LTC4302-1/LTC4302-2 LTC4305, LTC4306, I²C Filter SDAIN Short Pulse Misprocessing Issue

October 5, 2011

Date Codes for New LTC4302-1/LTC4302-2, LTC4305, LTC4306 Silicon with Fixed Input I²C Filter Circuitry

Product Errata

Figure 1. A 500ns Wide Logic High Short Pulse on SDAIN Causes No Issues with the LTC4306. After the Stop Bit, Which Completes the Command to Connect to Channel 4, SCL4 Follows SCLIN as It Should

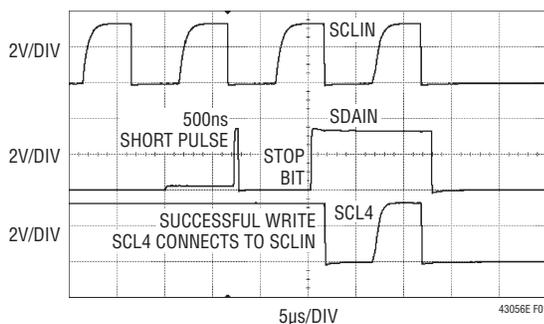
the problem using the LTC4306. The same SCLIN and SDAIN waveforms shown in the figures can cause similar problems in the LTC4302-1/LTC4302-2 and LTC4305. Figure 1 shows a successful write operation to connect the input SDAIN, SCLIN bus to downstream channel 4. The SDAIN short pulse is 500ns wide—wider than the maximum 340ns pulse width that can ever cause a misprocessing issue. SDAIN short pulses narrower than 150ns also never cause an issue.

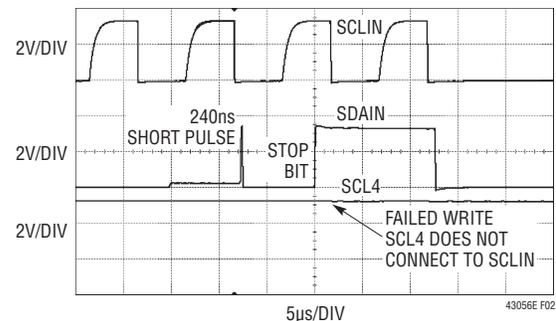
Figure 2 shows a failed write operation to connect to downstream channel 4, where SCL4 remains high after the Stop Bit. The SDAIN short pulse width that caused the problem for this particular unit was 240ns. Pulse widths narrower than 237ns and wider than 243ns resulted in successful write operations.

Because the ±3ns window causing the problem is so small, random variations in the system over time can cause the problem to be intermittent. For this reason, a Write Operation to a single LTC4302-1/LTC4302-2, LTC4305, LTC4306 may fail sometimes but pass at other times. The best way

to fix this issue is to ensure that the SDAIN short pulse never occurs. Adding capacitance to SDAIN to prevent the short pulse from rising above 1V is a good solution. This and other solutions are discussed in the next section.

- Observe the SDAIN short pulses before and after the 9th clock of each byte when the master is communicating with the LTC4302-1/LTC4302-2, LTC4305, LTC4306. Add capacitance to the SDAIN line to prevent SDAIN from ever rising above 1V during a short pulse. Adding the same capacitance to SCLIN is also recommended to optimize timing on the I²C bus.
